**UNDERGROUND INJECTION CONTROL  
PERMIT APPLICATION**

**Ute Tribal # 20-06**

**API # 43-013-31175**

# Technical Review Worksheet

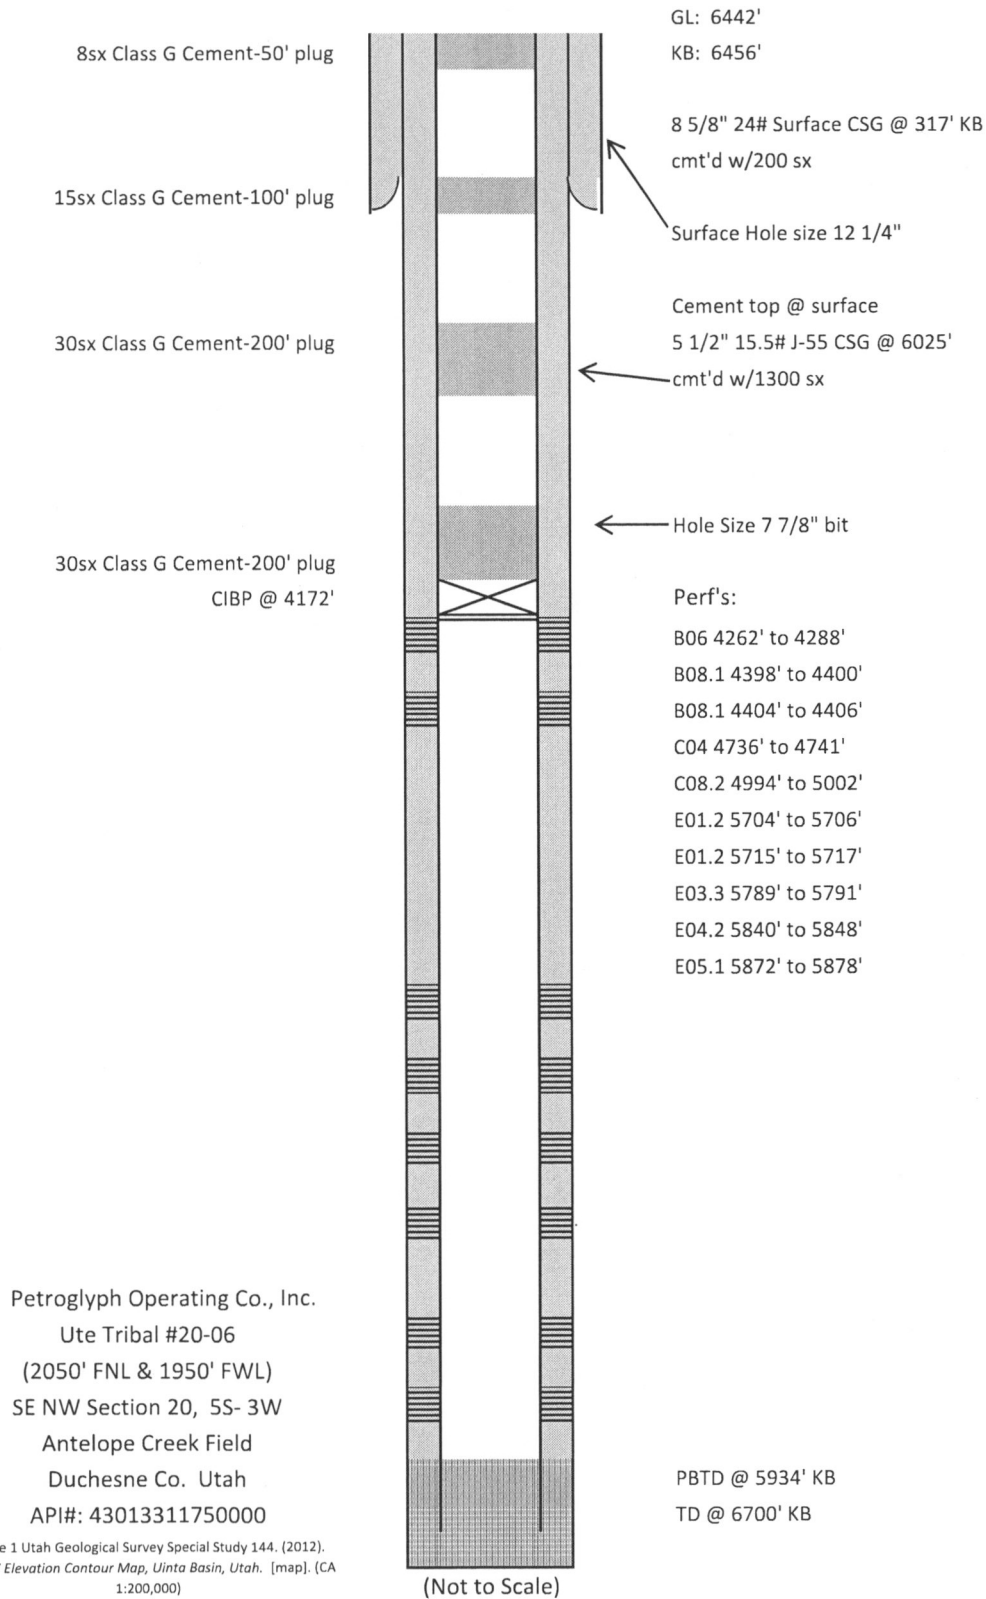
~~Now Old Production~~
